4 Flitcroft Street Facade Alterations Planning Addendum

REVISION 02 - AUGUST 2018

The following statement is submitted as an addendum to a previous application:
Application: 2018/2348/P

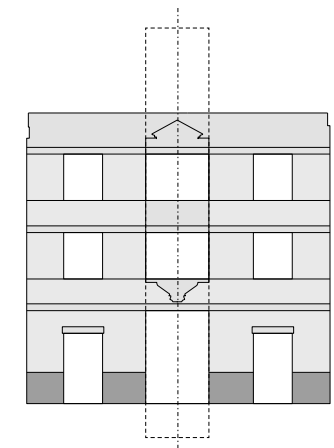
The following updates have been made following feedback on Revision 1 of this document.

- Glazing to left hand bay is now shown as fixed.
- Metal screening above the transom line in the left hand bay is now openable.

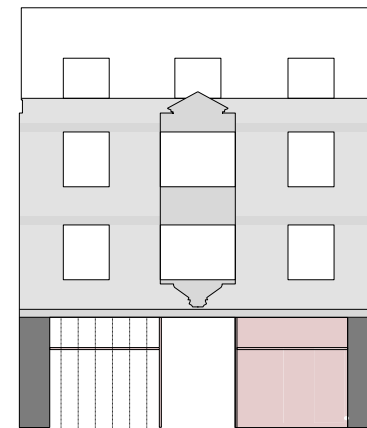
Two no. column fins introduced in line with reveals of central bay. Steel horizontals introduced to instate heirarchy of bay at ground floor.

3.1 Development from previous application

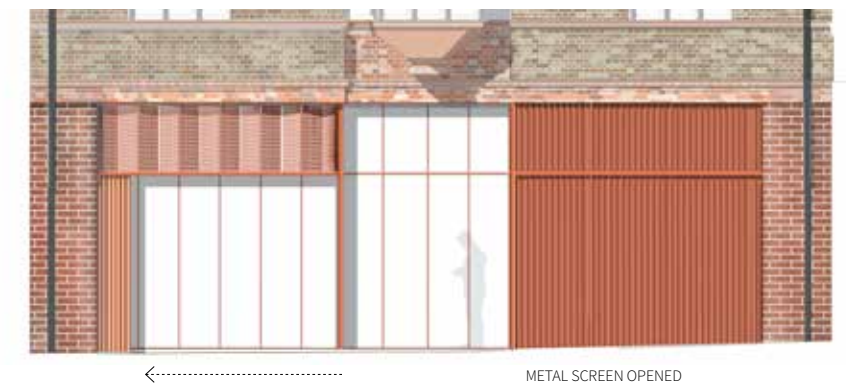
RENDER TO BE REMOVED FROM UPPER BUILDING. ORIGINAL BRICK TO BE REPAIRED AND REPLACED WHERE NECESSARY.

EXISTING BRICK BANDING TO BE CLEANED AND REPAIRED.

UPPER WINDOWS TO BE REPLACED WITH TIMBER FRAMES WITH FENESTRATION TO MATCH ORIGINAL CONDITION.

NEW BASE COMPRISED OF GLAZED BRICK PIERS, COLOURED METAL SCREENS AND GLAZING AND TWO STEEL COLUMN FINS AND TRANSOMS.
